**VALUE ENGINEERING STUDY
OF
RECONSTRUCTION OF I-64/
KY 180 INTERCHANGE
Item Number: 9-60.00**

**Boyd County, Kentucky
October 17-21, 2005**

**Prepared by:
VENTRY ENGINEERING, L.L.C.**

**In Association With:
KENTUCKY TRANSPORTATION CABINET**

VE RAMP
 D

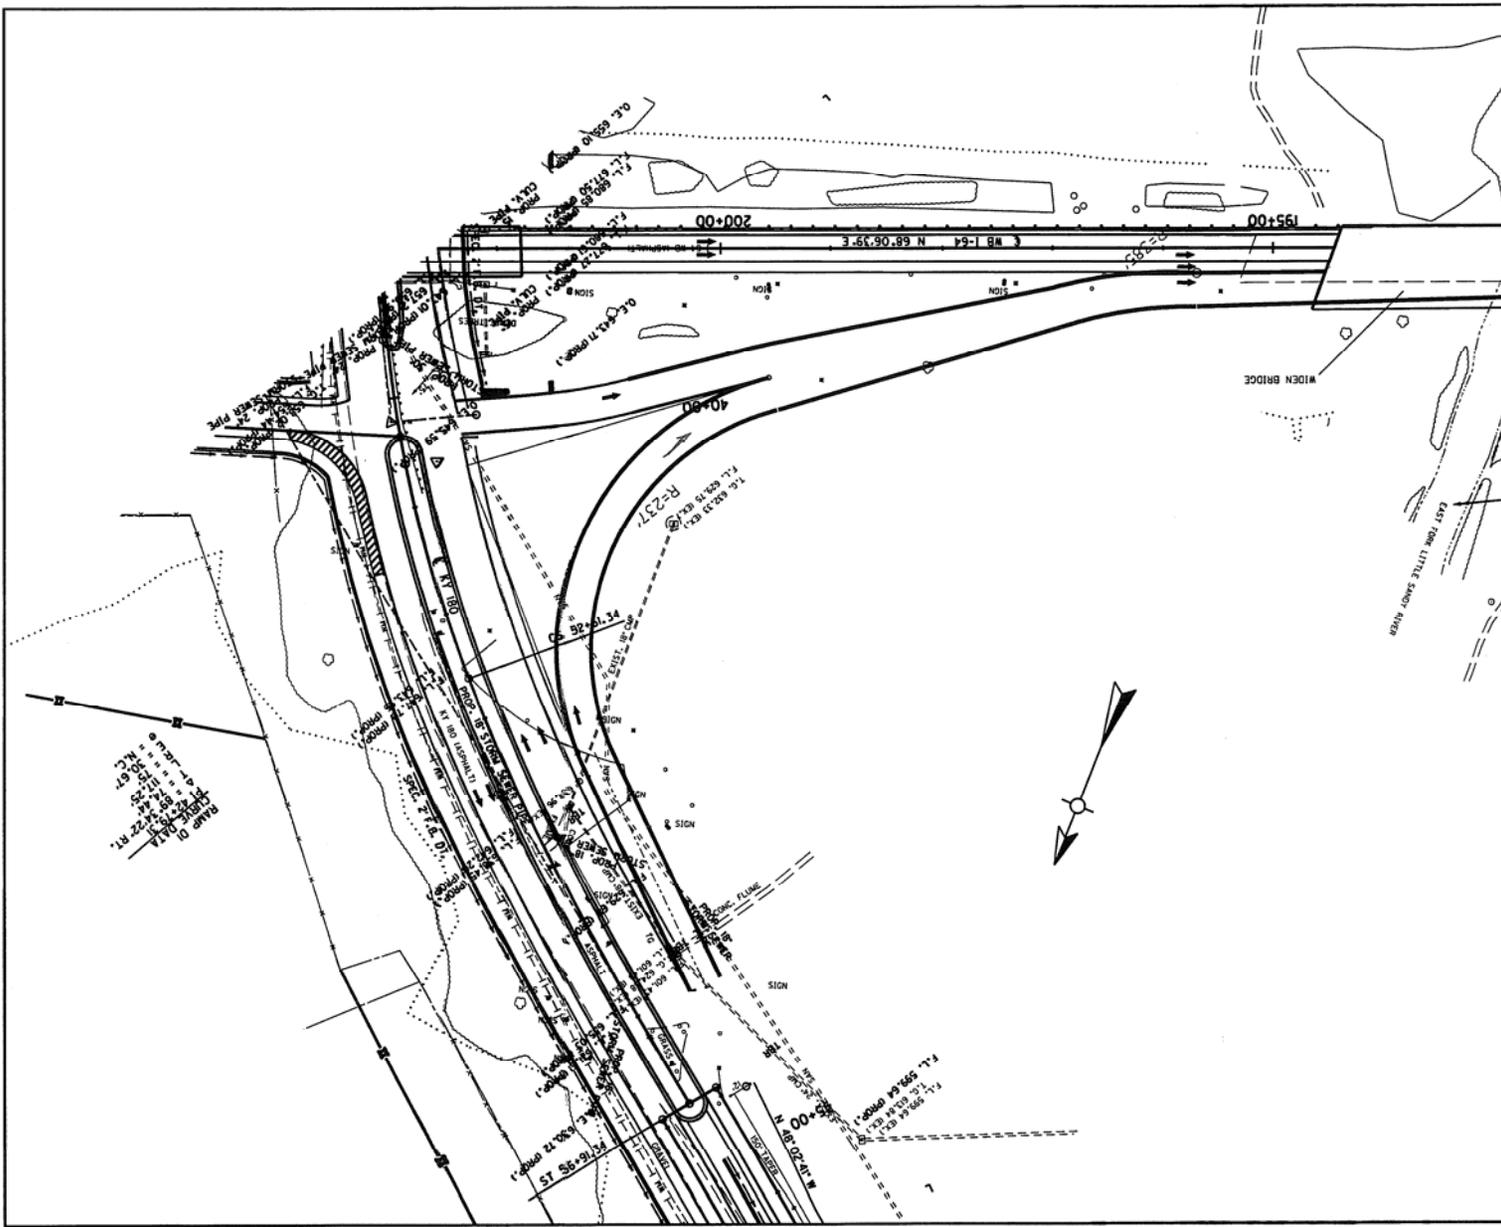
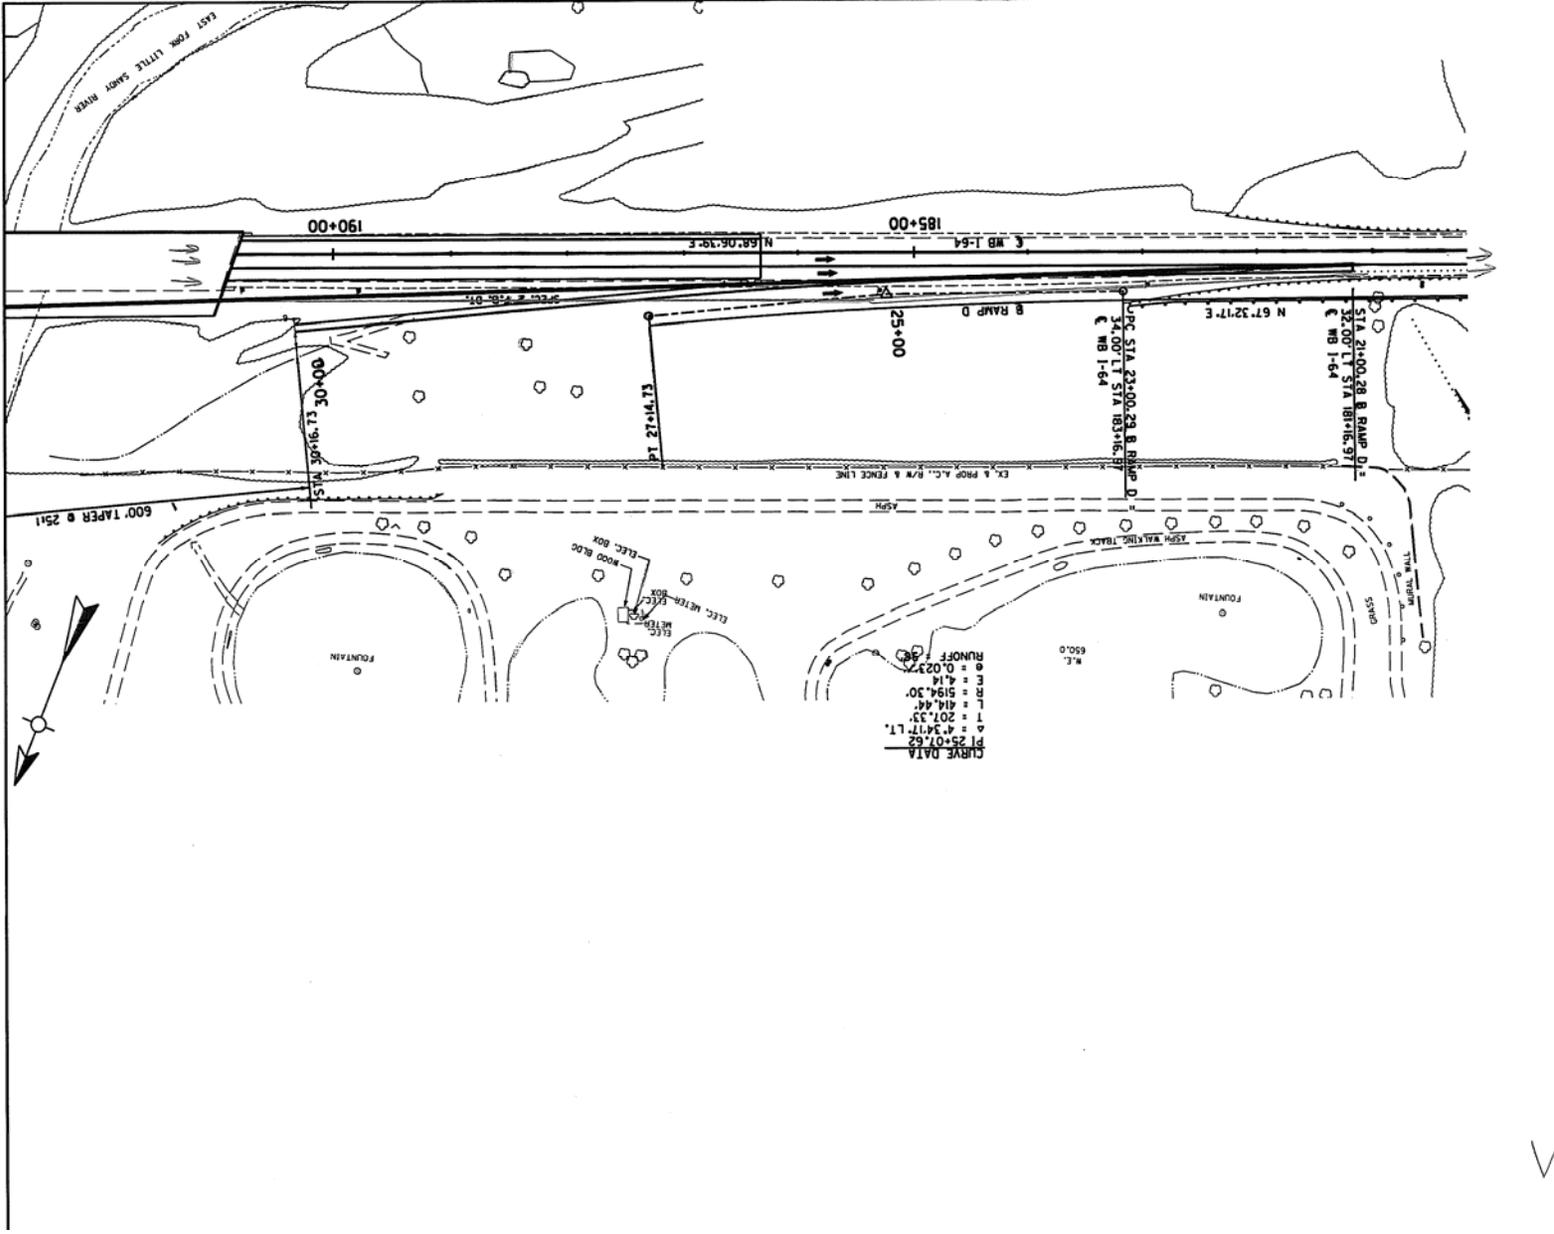
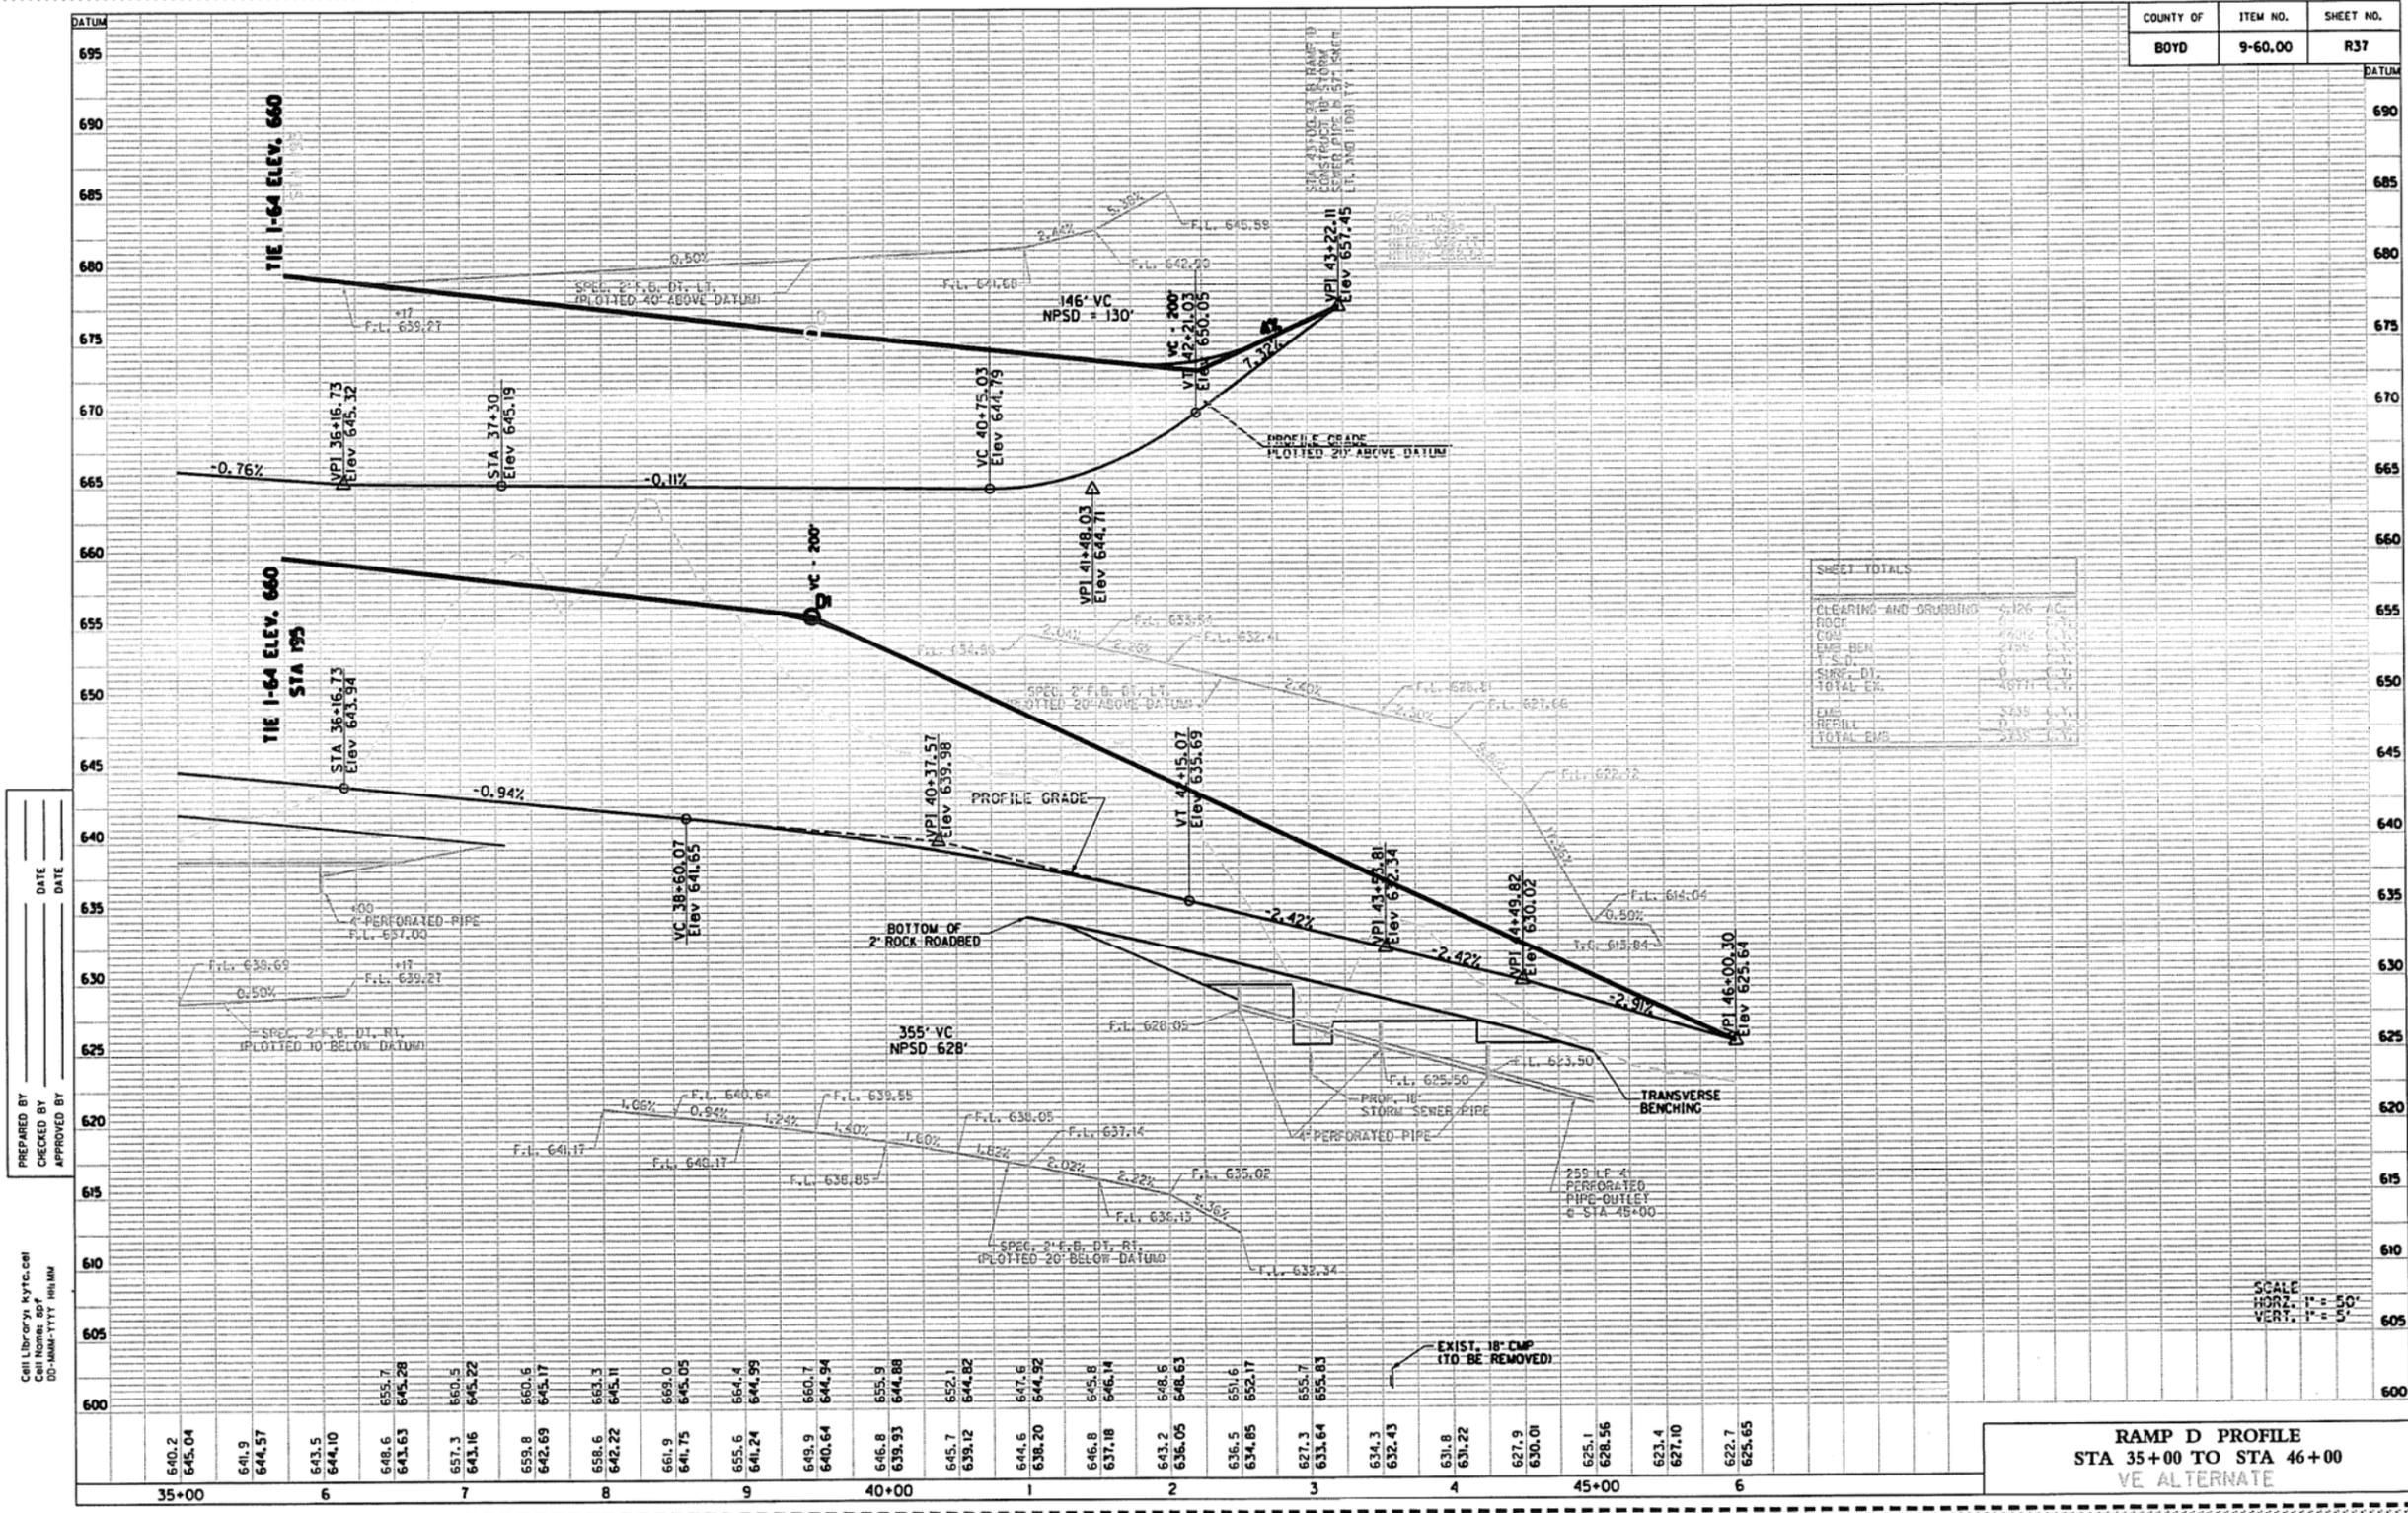
The VE team recommends that the intersection of the A and D ramps with KY180 be modified to provide a better operating intersection in closer conformity with Kentucky's desired intersection criteria. The VE team believes that desirable intersection criteria should control over open road criteria at a major signalized intersection.

“As Proposed”

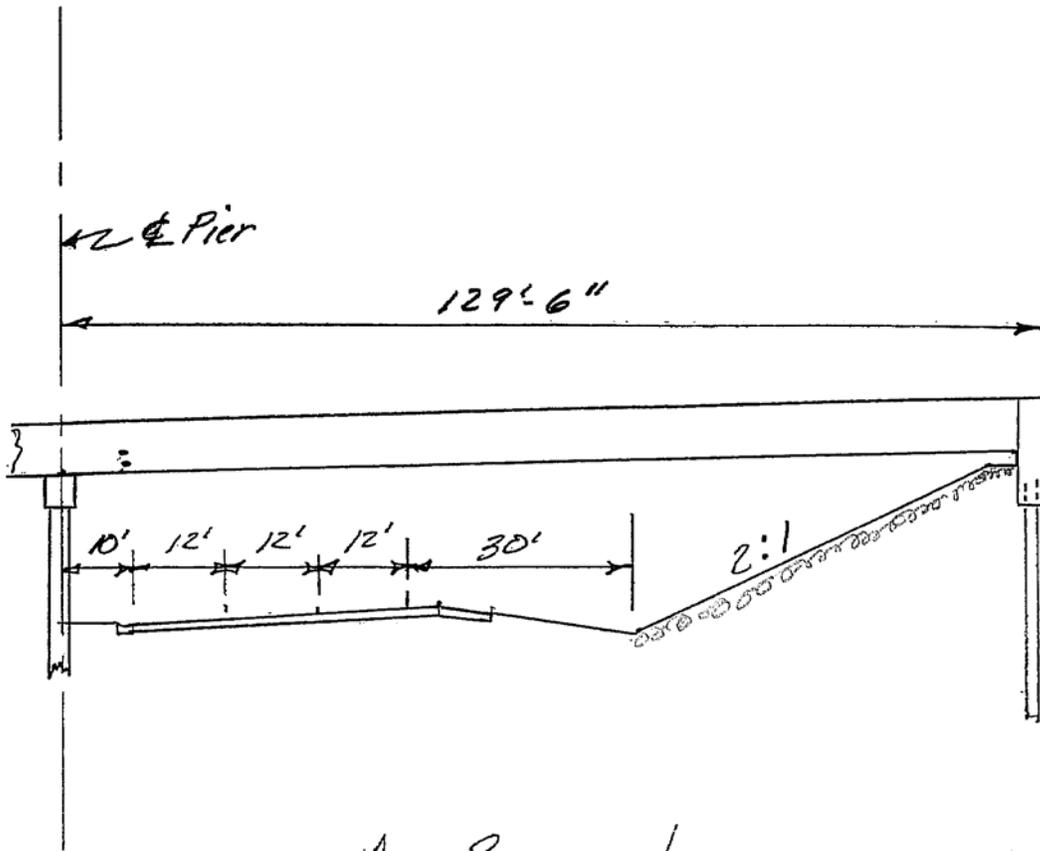
The as proposed uses two span prestressed girder bridges over KY 180 with conventional spill through abutments. The toe of the 2:1 berm slope is 30 ft. from the edge of the through-lane. This results in a 246 ft. long WB bridge and a 253.2 ft. long EB bridge. See attached sketch.

Value Engineering Alternative Number 4

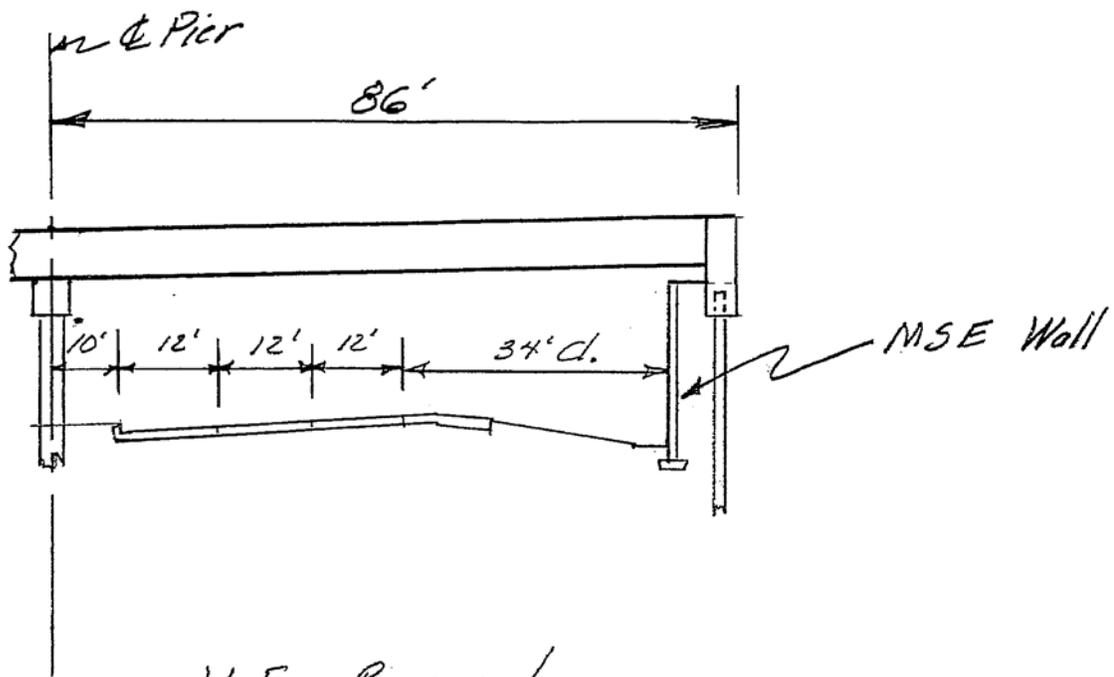
Use vertical MSE walls at the abutments. The face of the MSE wall is located 34 ft. from the edge of the through-lane. This provides a 30 ft. clear zone and 4 ft. flat area for ditch drainage and a platform for the base of the wall. This results in a 160 ft. long WB bridge and a 163 ft. long EB bridge. See attached sketch.
